**Re: PA22-033 – East Sunnyside PRD – Technical Review 1**  
4617 87<sup>th</sup> Ave NE – APN(s) 00590700016201 / 00590700016202

After preliminary review of the above referenced proposal, the Planning Division has the following comment(s):

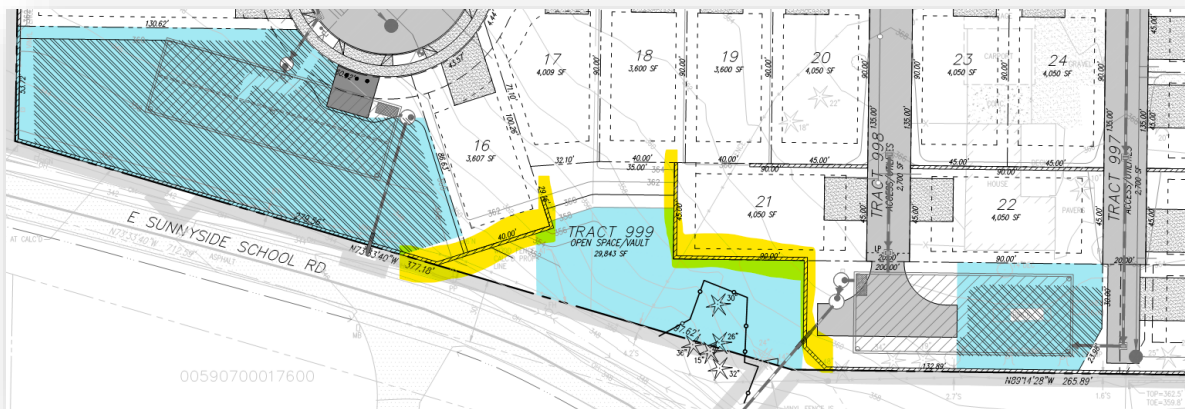
8. Based on the below image, the central area of proposed Tract 999 would be blocked off by retaining walls (see highlight). As proposed, this open space tract would not meet the requirements of *being accessible and convenient to all residents in the development* per MMCG.080.100(4). As proposed, that area would be entirely isolated and inaccessible.
